**ADDENDUM NO. 1  
TO  
PROPOSAL AND CONTRACT DOCUMENTS**

**RUSSELL REGIONAL AIRPORT  
ROME, GEORGIA**

**NORTH TERMINAL LANDSIDE IMPROVEMENTS  
SANITARY SEWER**

**DATE: JUNE 12, 2014**

Scale: **AS NOTED** Drawing Number: **PP-1**

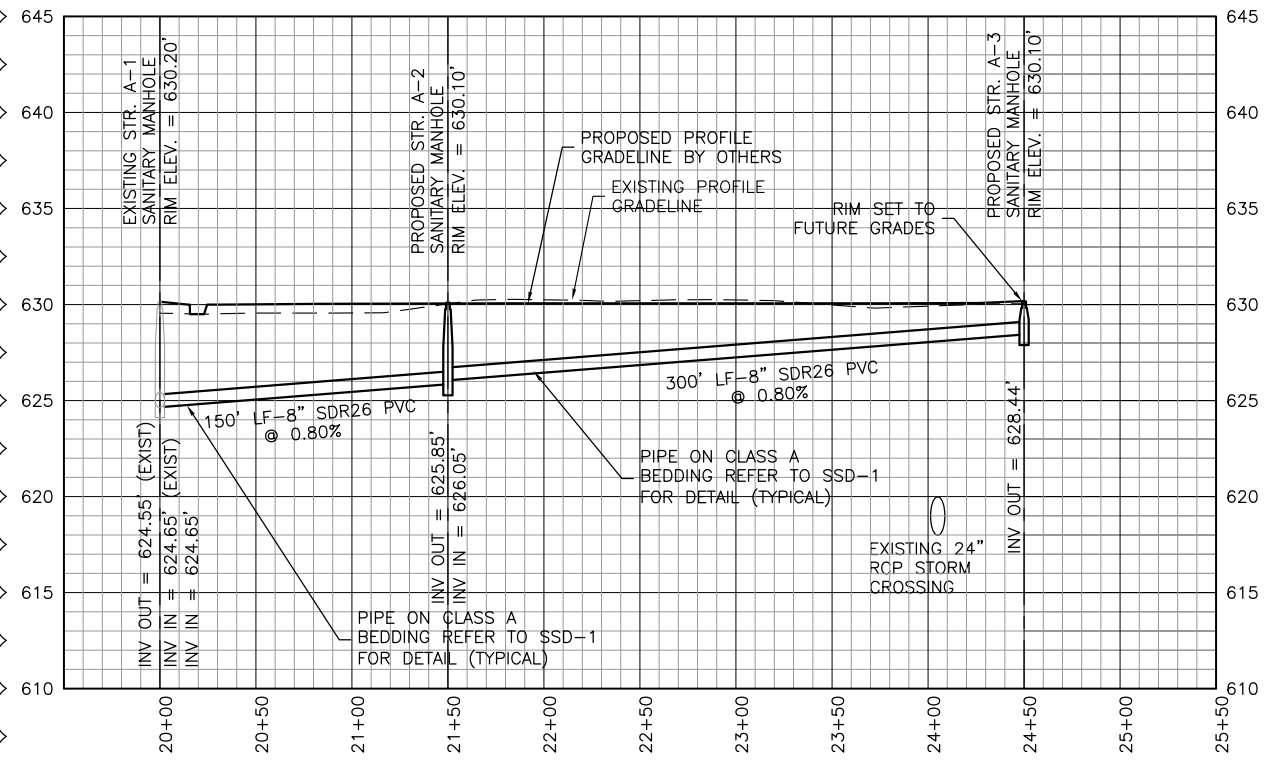
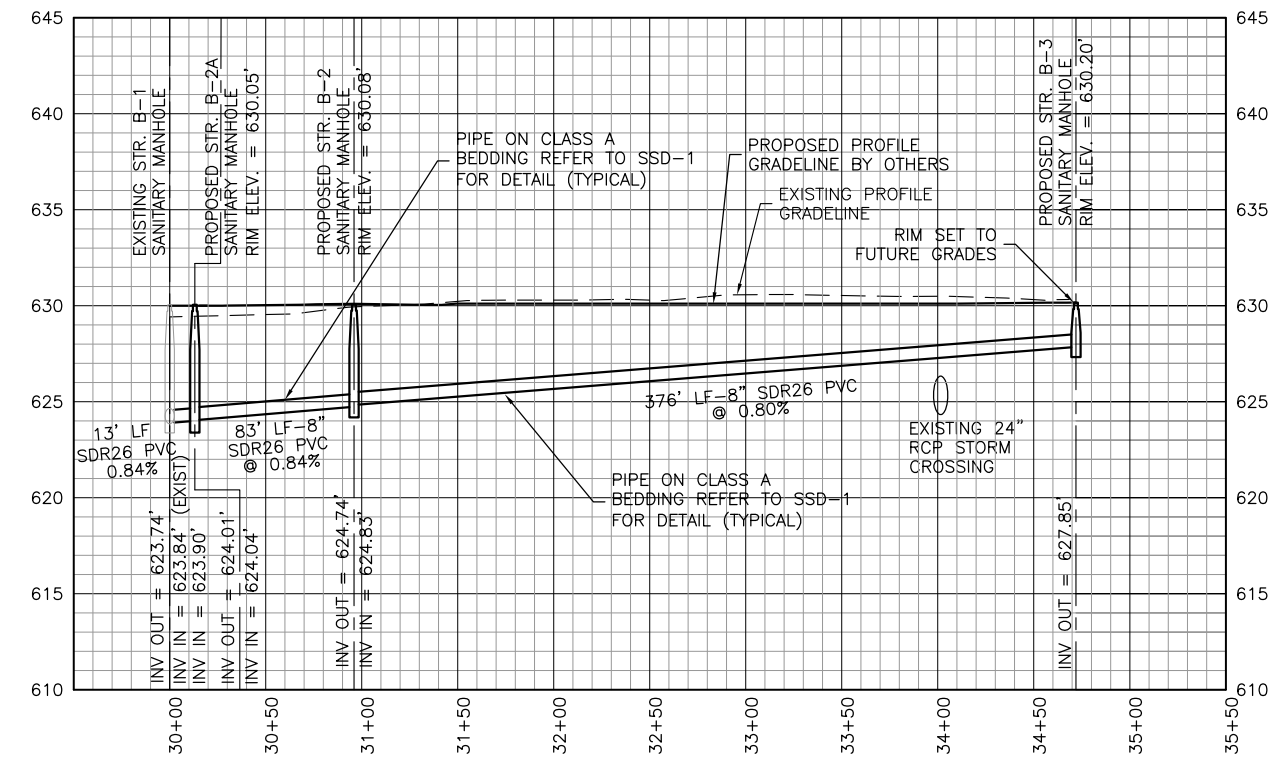
Bidders are referred to Drawings SSP-1 and PP-1 which are included as attachments to this Addendum. These Drawings are issued to clarify inclusion of an additional sanitary sewer manhole (Structure B-2A) and revisions associated with the new Structure.

GDOT Project Number:  
Date: **OCTOBER, 2013** Sheet Number: **1** of **2**  
Scale: **1"=50'** Drawing Number: **SSP-1**

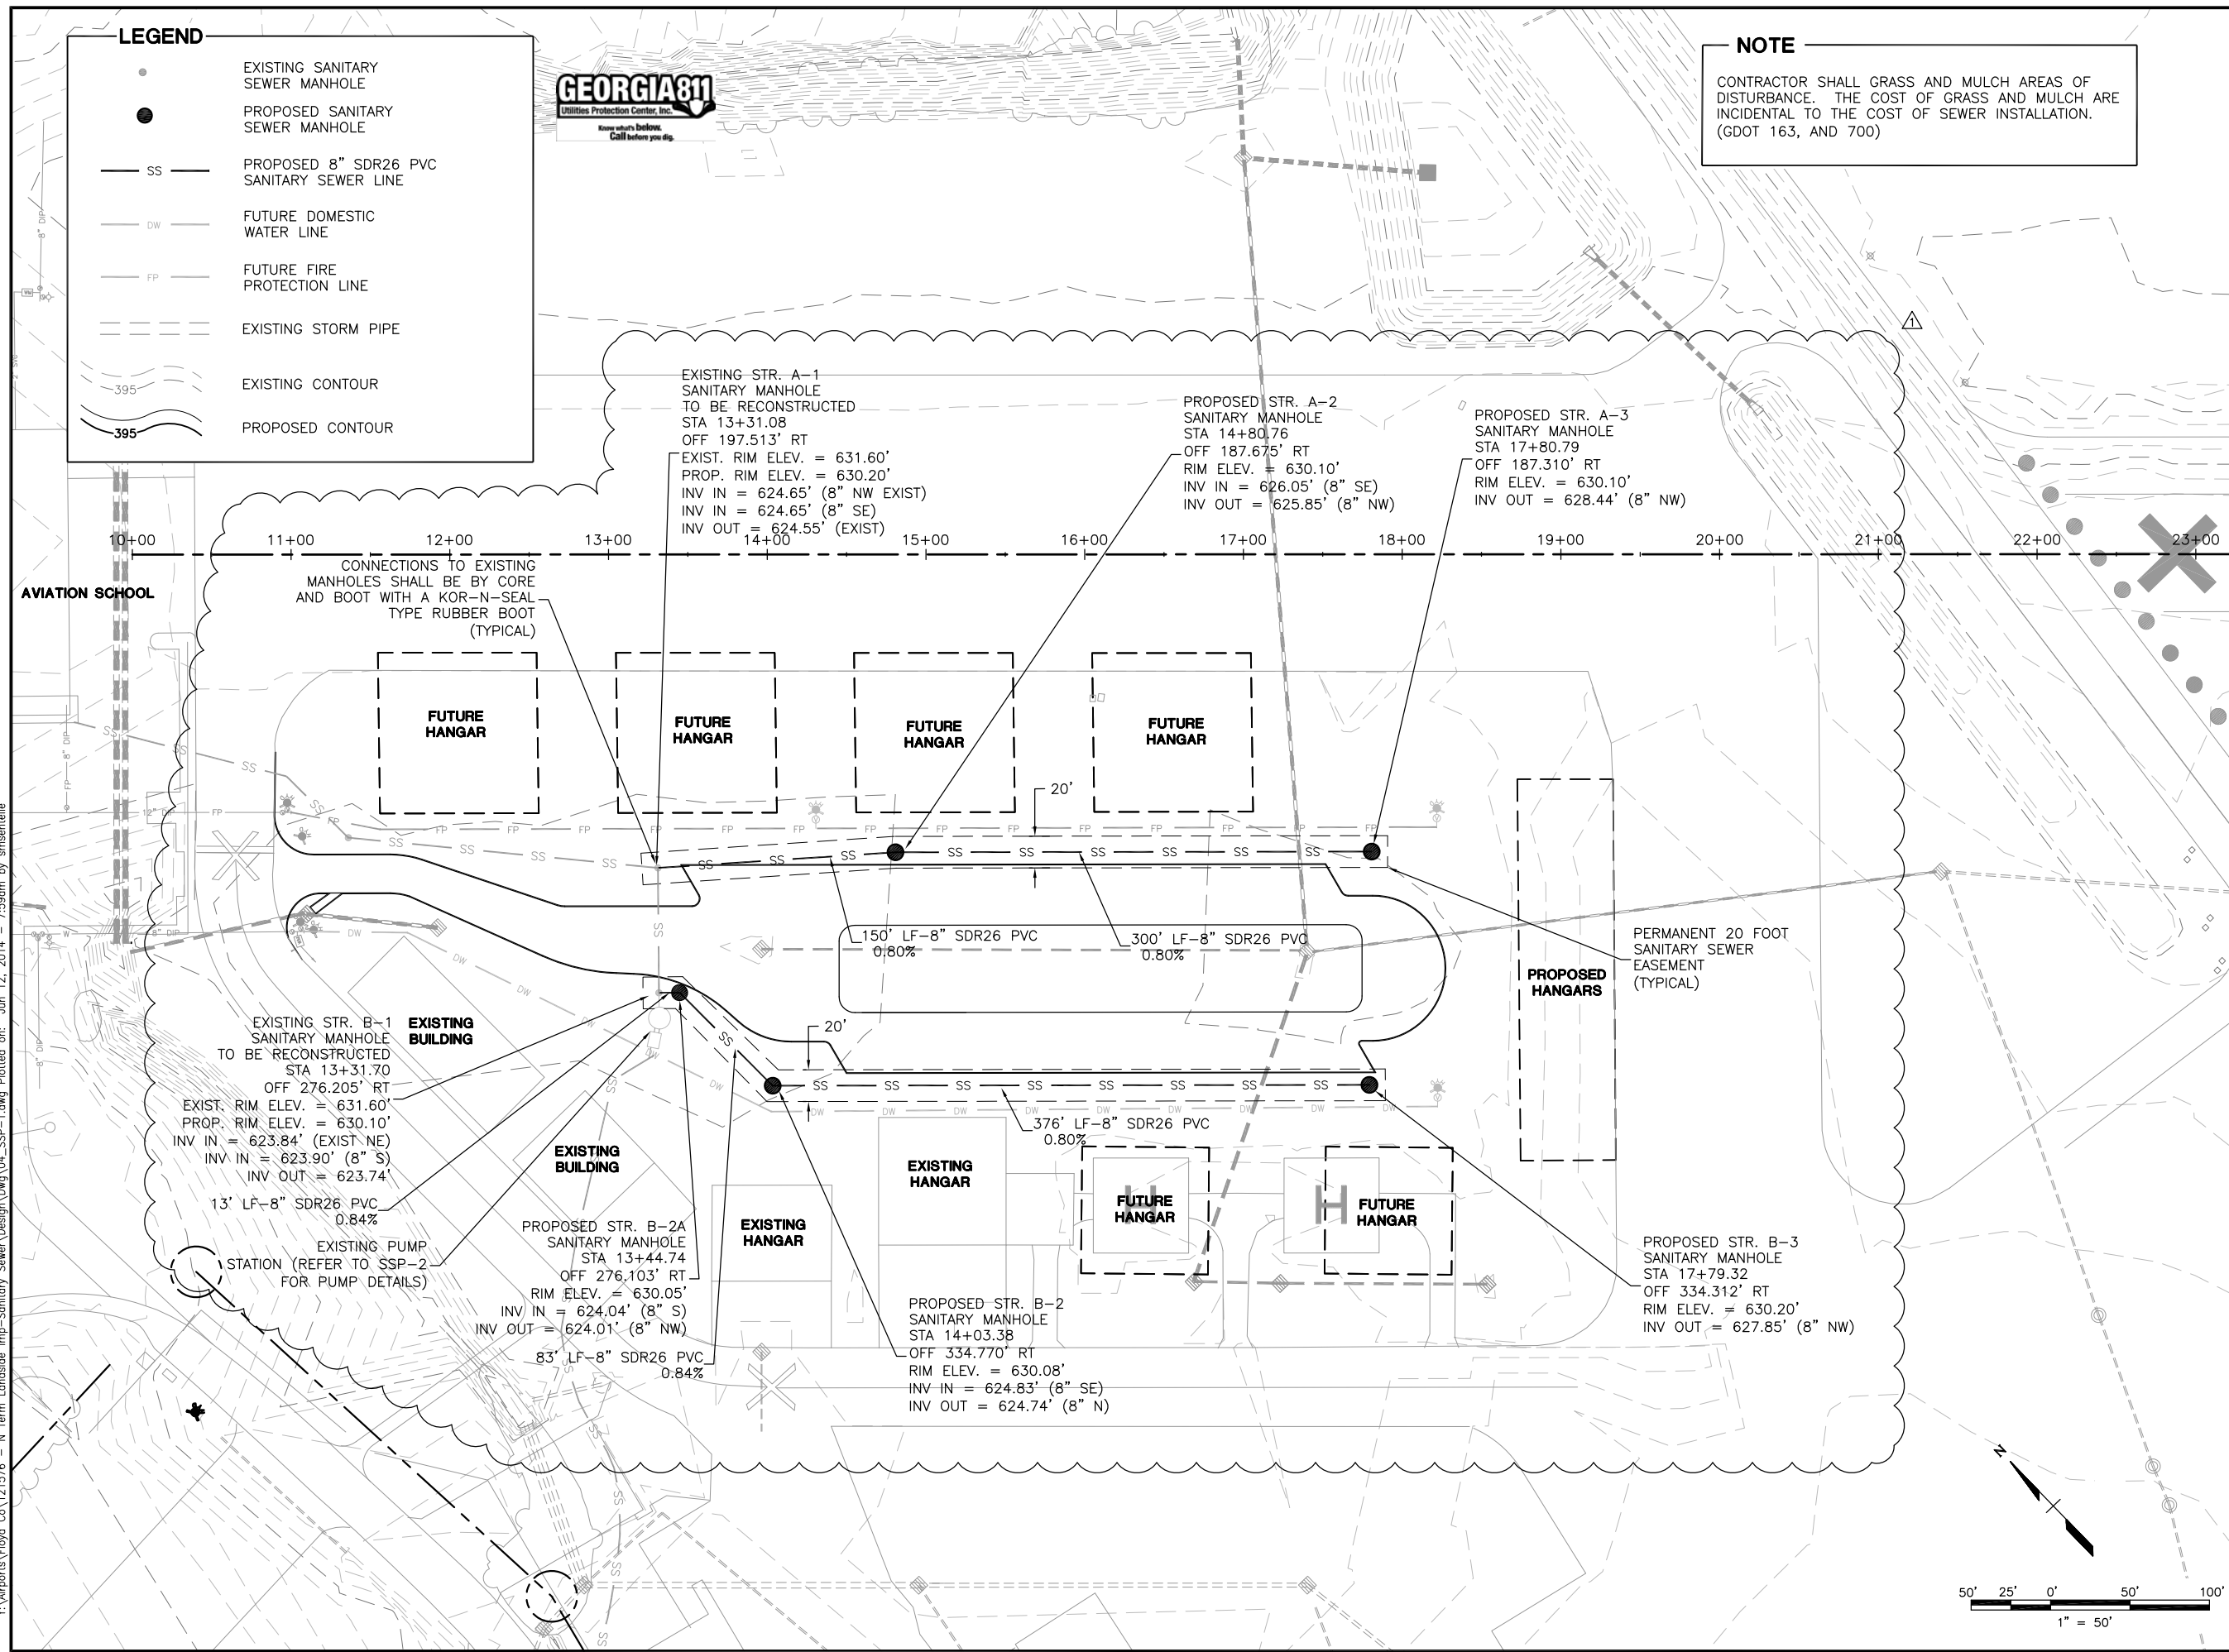
Bidders are referred to Drawing SSP-1. Bidders are reminded that there are two (2) existing sanitary sewer manholes on the project site (Structures A-1 and B-1) which will require adjustment to bring the rim elevations to proposed grades. Adjustment of these structures will be paid for under Item 4 in the Bid Schedule (Specification 611-3020).

Bidders are referred to Drawing SSP-1. Bidders are advised that payment for the new sanitary sewer manholes (Structures A-2, A-3, B-2A, B-2, and B-3) will be made under Item 6 in the Bid Schedule (Specification 668-3300) and shall include the entire structure, regardless of its height.
